TECHNICAL ANALYSIS

Field Adjustments for Willow Creek Refuse Removal Plan ACT/007/004-95G December 18, 1995

DRILL HOLE MC-6

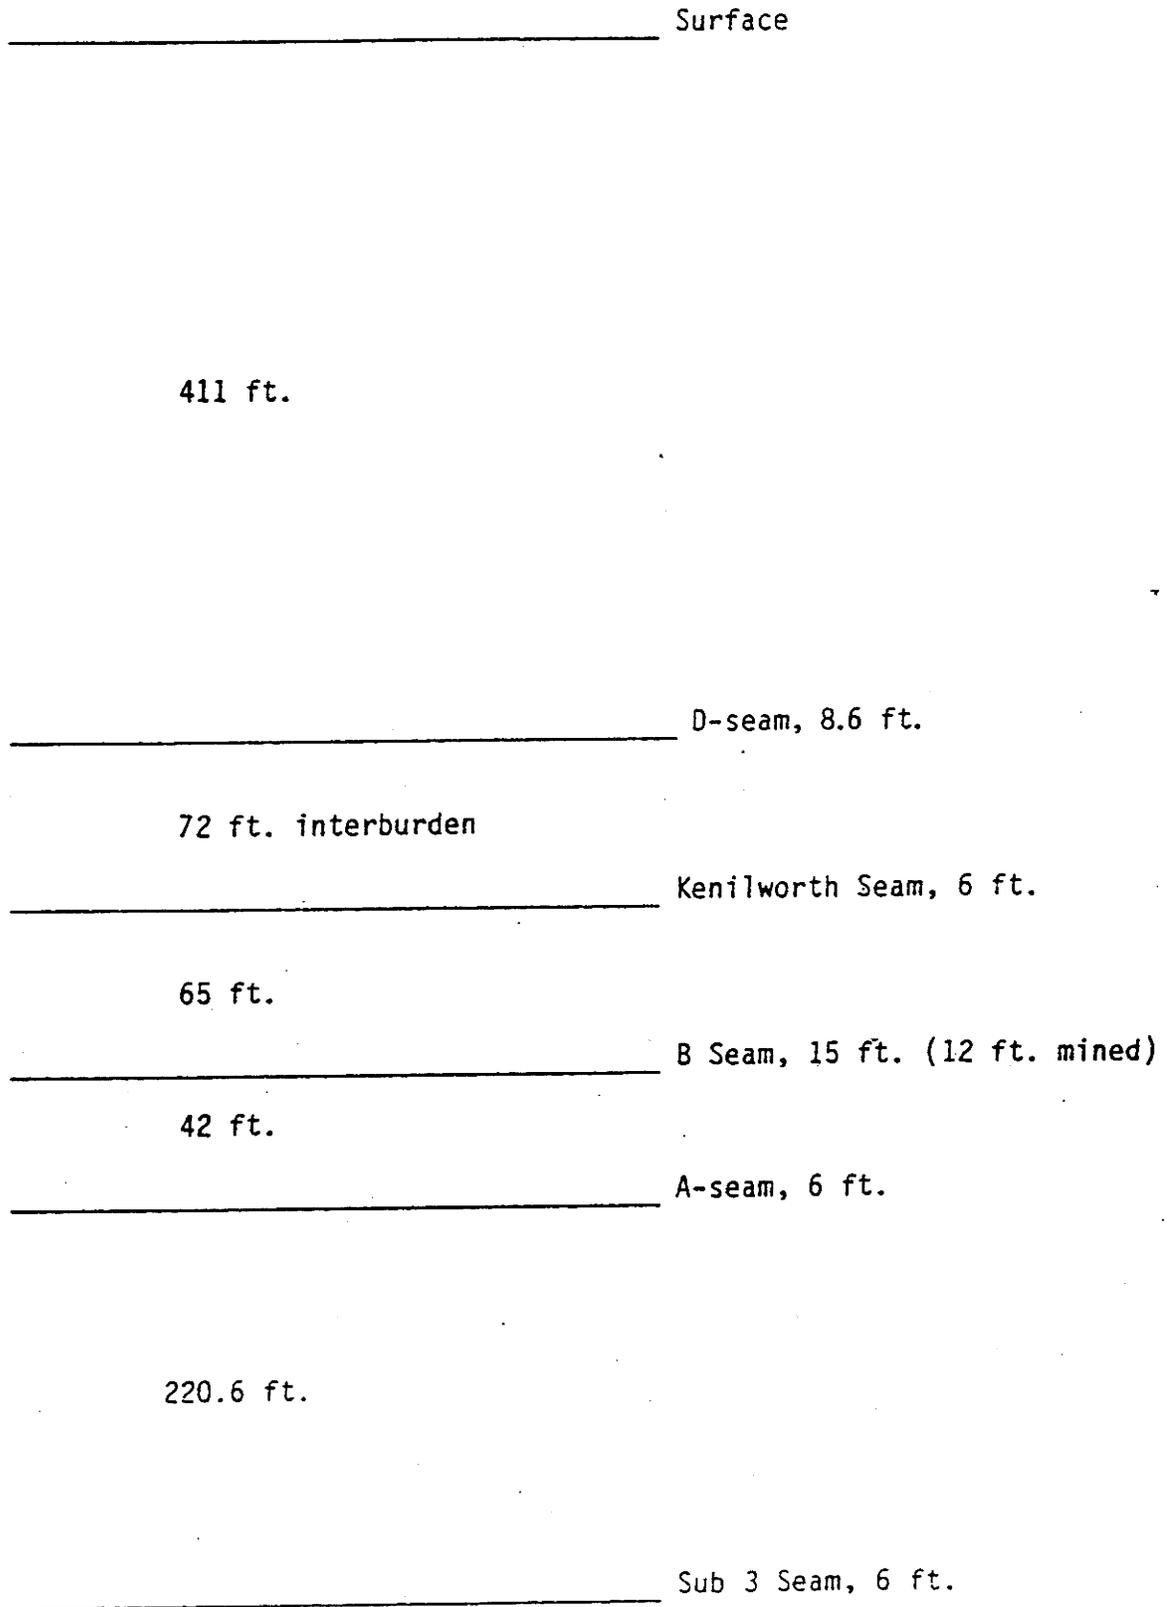
Although this hole was not drilled through the Aberdeen to the Sub 3 Seam, the occurrence of the Aberdeen is very consistent throughout this area. Detailed lithologic information was submitted for three other drill holes and in each of these holes, the Aberdeen sandstone existed.
